## COMMENTS FOR EXPERT CONSENTING PANEL, ENVIRONMENTAL PROTECTION AUTHORITY

Application Name: Quarterdeck  
EPA Reference: FT 000089  
Applicant: Box Properties Investments Ltd

From: Cockle Bay Residents and Ratepayers Association (CBRRA)  
Date: 8 April 2024

Figure 1 Geomaps of the area indicating the presence of local streams providing drainage and flood prone areas. (Red arrow indicates site)

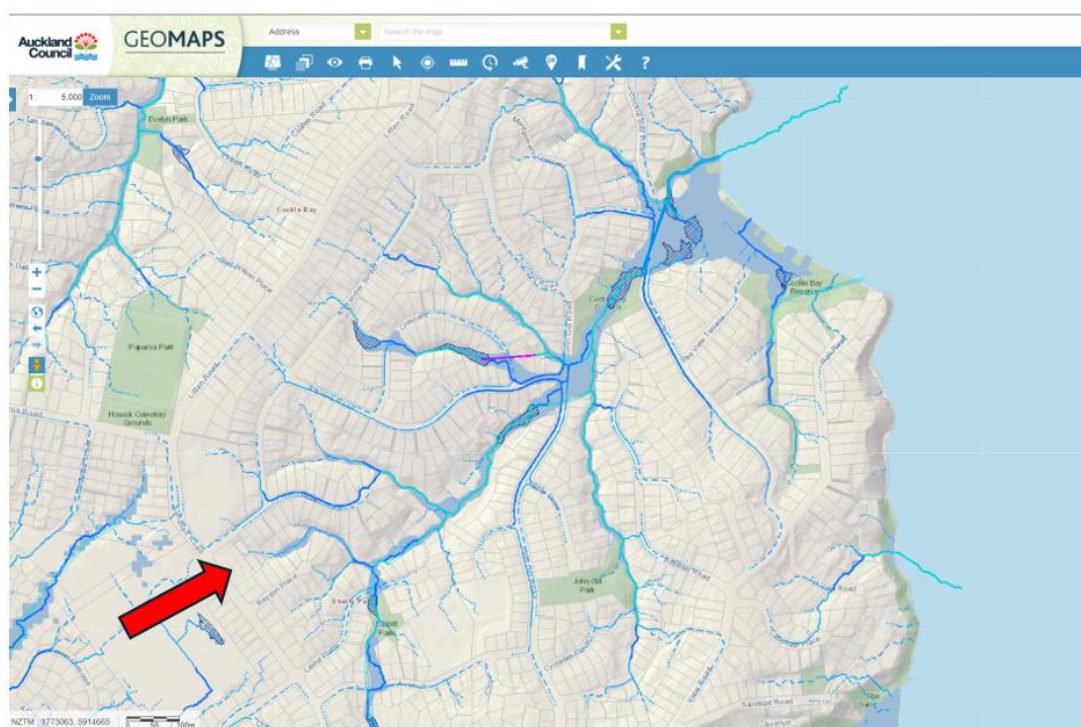
72 Section 8.1.3 of the AEE states that “The site is located in a well-established suburban environment, without the presence of any streams, watercourses or ecological areas. As such, the proposal is unlikely to affect any ecosystems or result in the physical disturbance of habitats” and “No other natural hazards have been identified” and “as such, there is no risk to the neighbourhood, the wider community or the environment”<sup>25</sup>.

73 Geomaps plainly indicates this is inaccurate.

- 74 The DHC Infrastructure Report states that there is no need to consider floodplains or overland flow paths for development (Section 5 page 12) even though the aerial view on the same page includes a reference to a 1% AEP floodplain only a short distance from the site. In these circumstances we would have thought that the developer has a duty of care in assessing downstream impacts of waterflows, all the more so as Healthy Waters has deemed the streams are on private property.

- 75 Possibly the above statements are disingenuous. There are no streams, watercourses or flood plains on the site itself. But as Ms Rankin's submission and Geomaps clearly show, there are multiple streams draining this catchment, including a stream flowing through adjacent properties located on Reydon Place and another close to Trelawn Place, which, like Reydon Place, borders the development. Geomaps also shows a number of floodplains on these streams.
